Packet Guide
City of Charlottesville
Board of Architectural Review
Regular Meeting
November 19, 2024, 5:30 p.m.
Hybrid Meeting (In-person at CitySpace and virtual via Zoom)

Certificate of Appropriateness Application

BAR # 24-11-02

946 Grady Avenue; TMP 310060000

A8

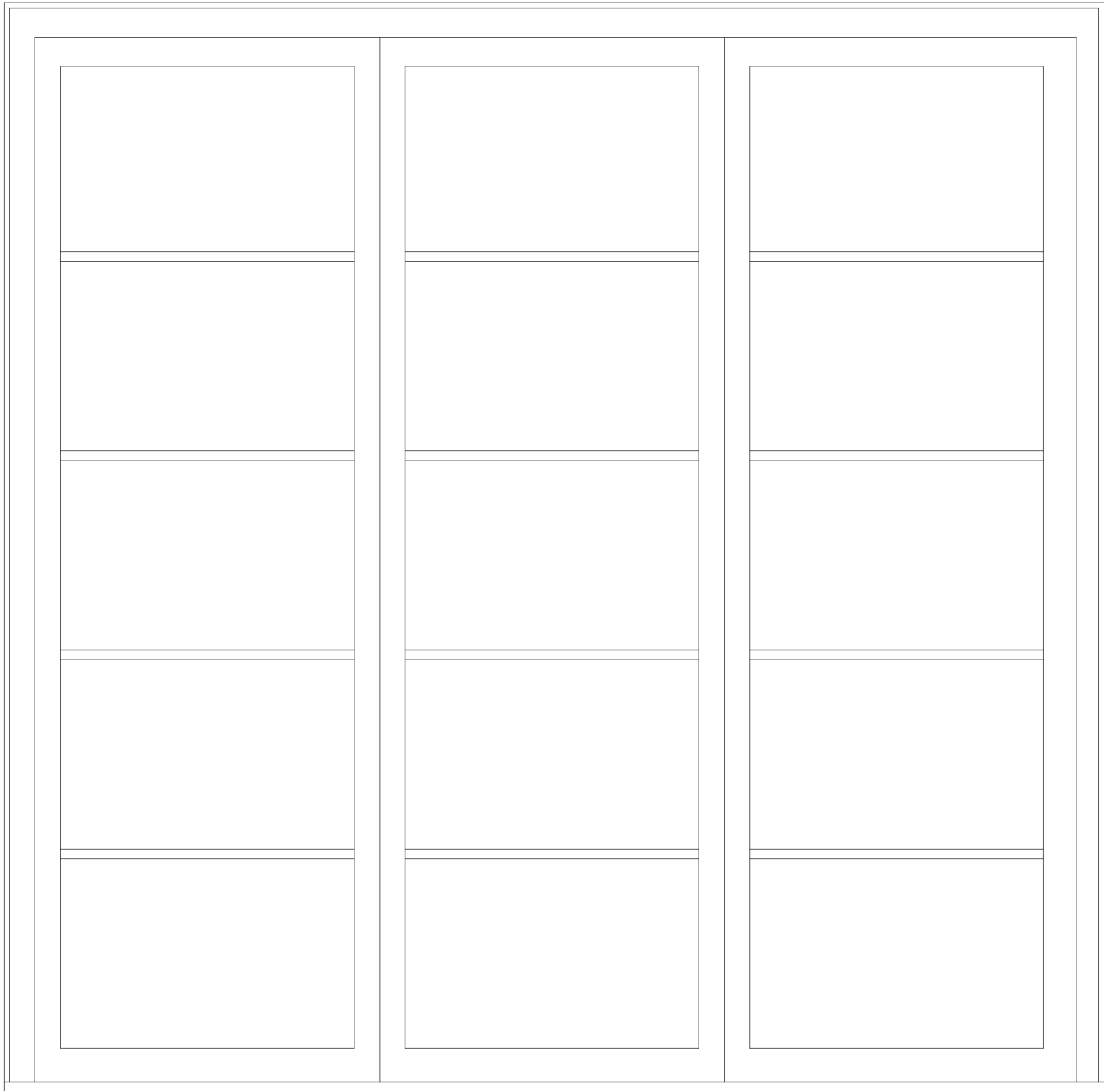
Two options proposed for the new, operable windows:

- Option A: Standard garage door type- Model 511 by Overhead Door doors.
- Option B: Folding, accordion style window- Model FTS60 by Panda.

Option B Tri-Fold Door Door
When open, panels extend 30" from face of building to the exterior.

Option A Overhead Door 511

The entry door and windows to be modified are not original and were installed during the approved rehabilitation of the former Monticello Dairy building (BAR #17-09-02). Additionally, while the work was never done, in November 2020, the BAR approved rearranging the non-original doors and windows at the west elevation.

116 West Jefferson St. For discussion only Nov 19, 2024

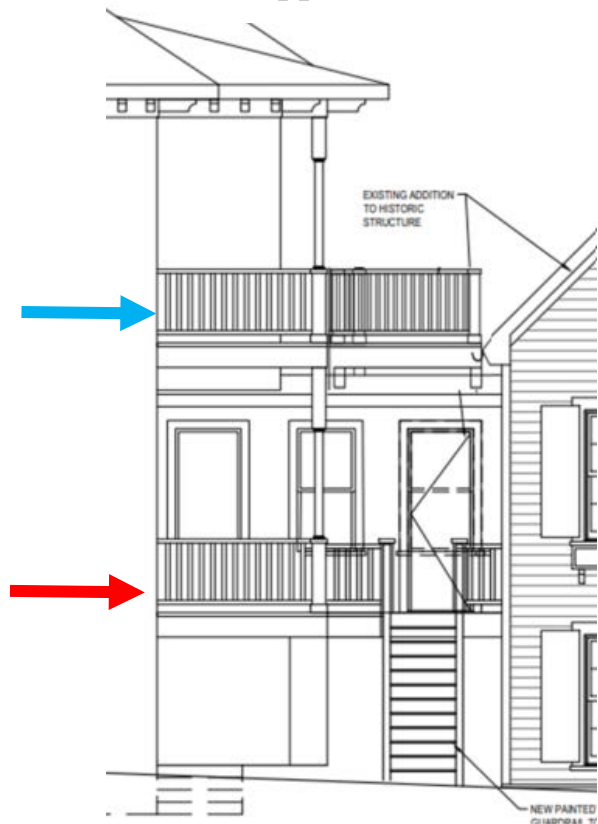
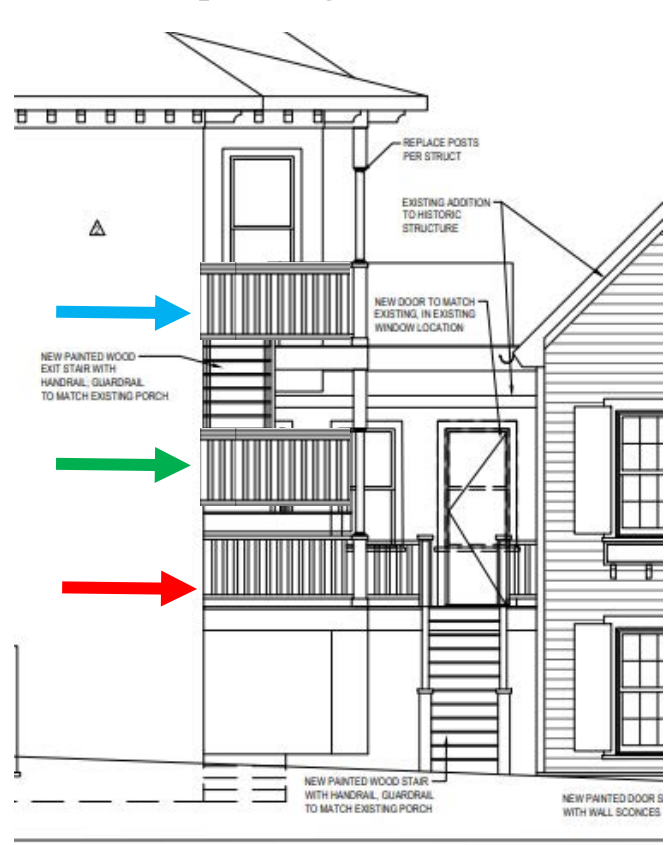
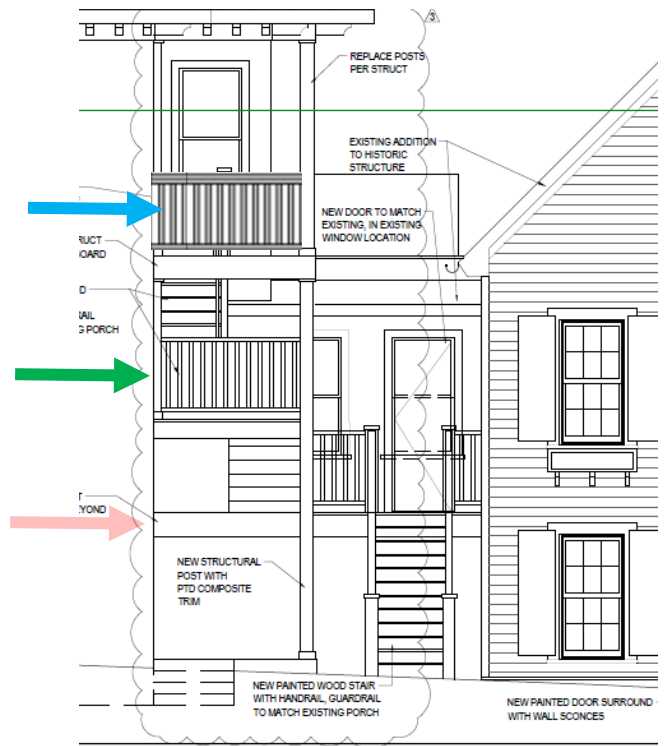
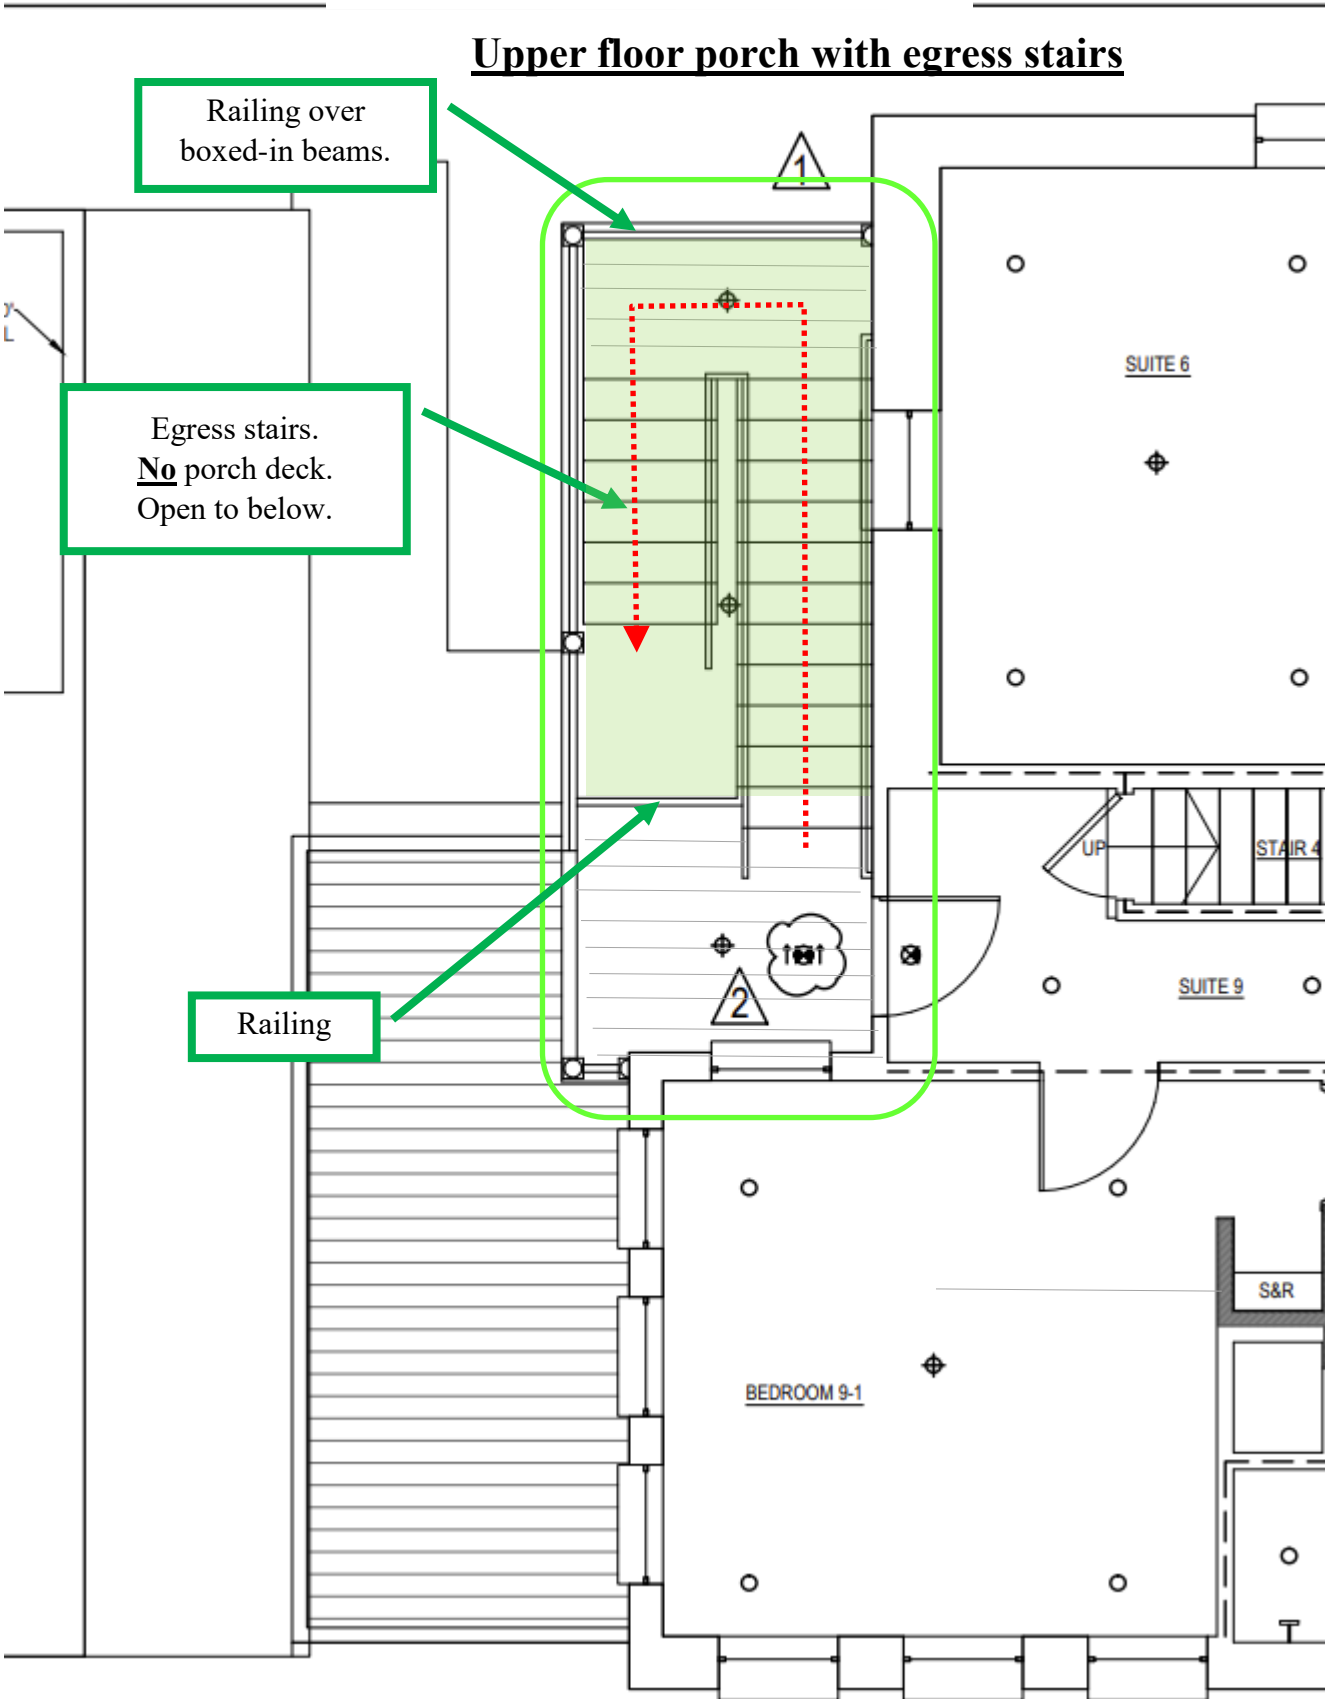
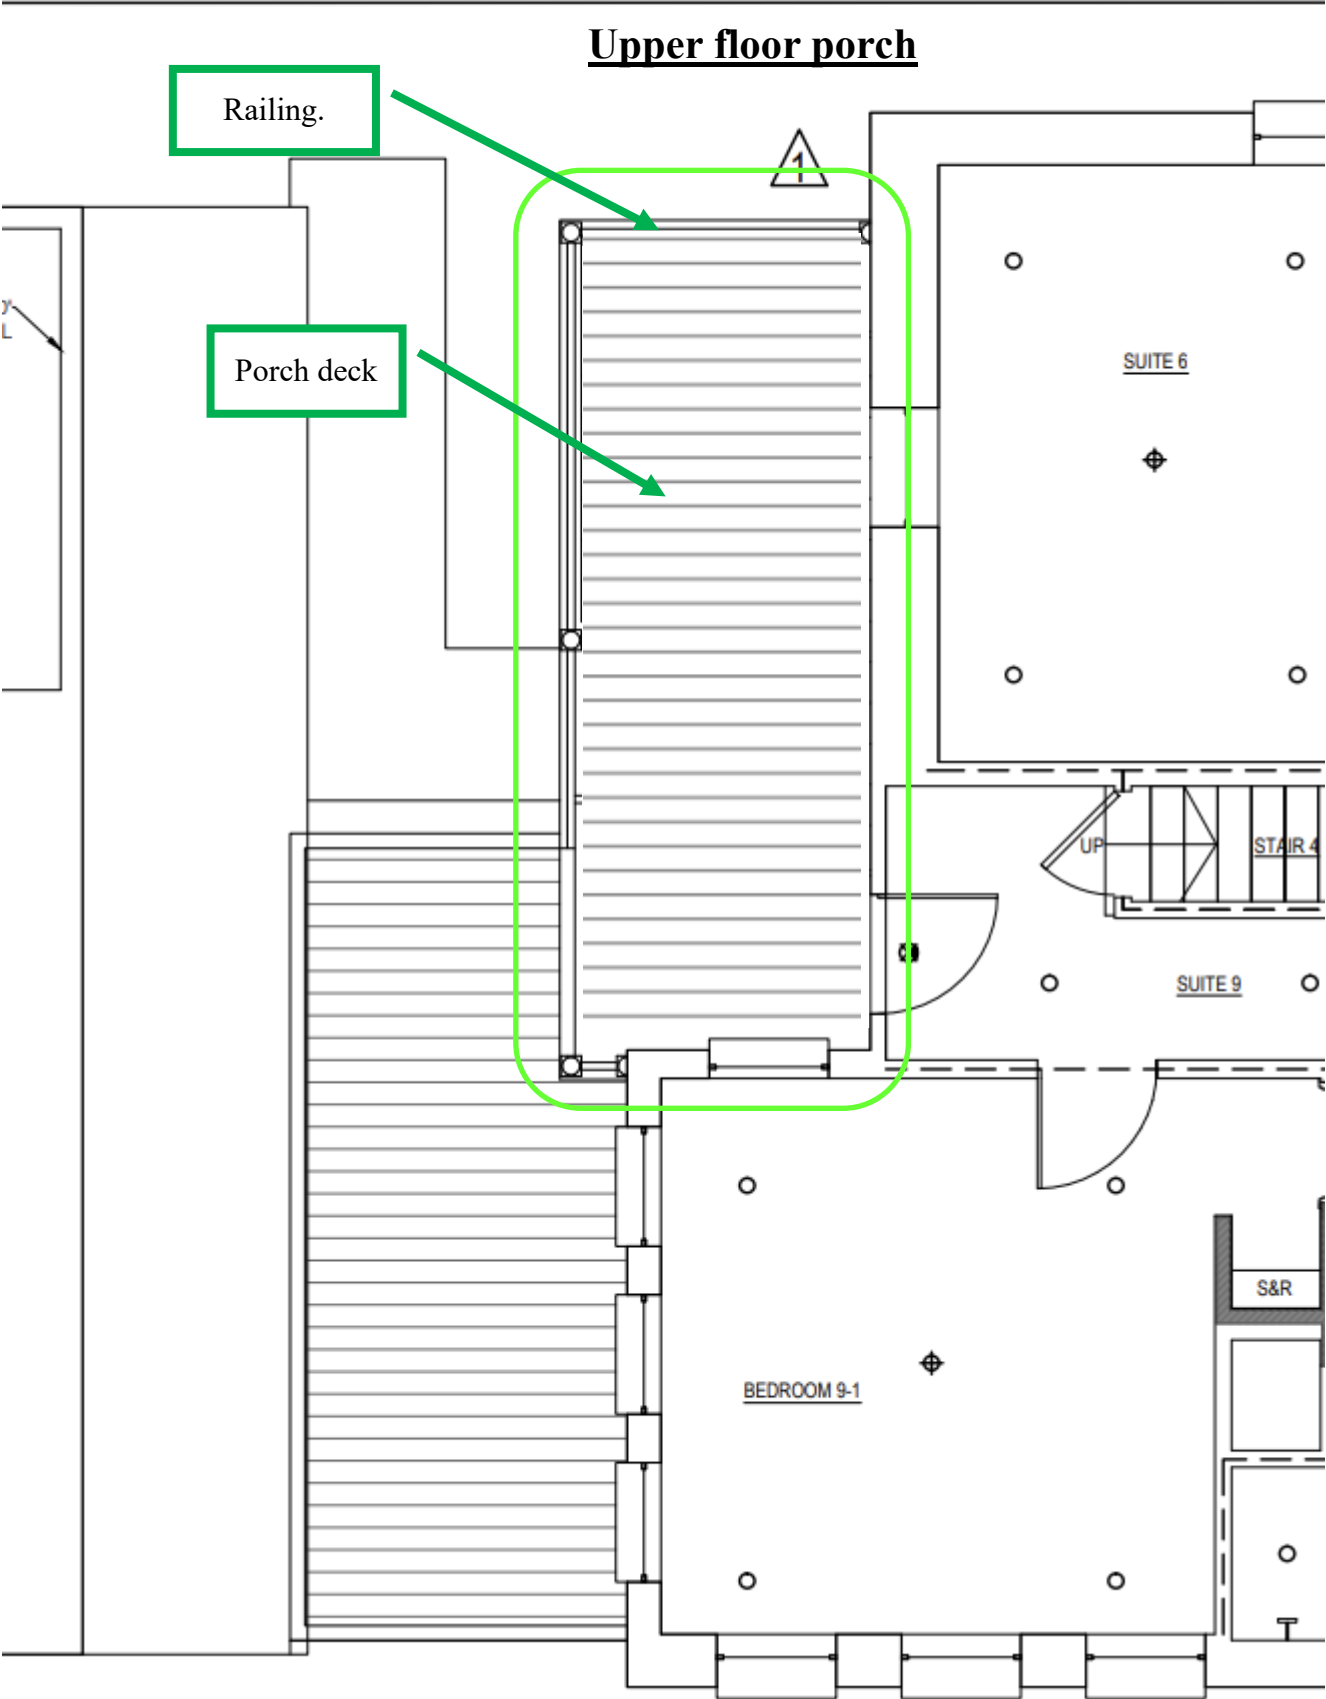
Alterations underway will allow the building to be used for lodging, which, per the Building Code, requires upper story egress at the rear of the historic house. Following consultation with the City's Code Official, it was determined stairs must be constructed at the rear elevation.

Staff reviewed the options with the architect and contractor, and in lieu of attempting to incorporate the new stairs *into* the porches, staff suggested it was better to simplify the design and focus on accommodating the required stairs. With that, staff suggested eliminating the lower porch deck and railing. And at the upper porch, retain the railings (above a boxed-in beam), but eliminate the decking. (Retaining the upper porch perimeter eliminates the need for, and appearance of, *two-story posts*.)

Solution proposed by staff
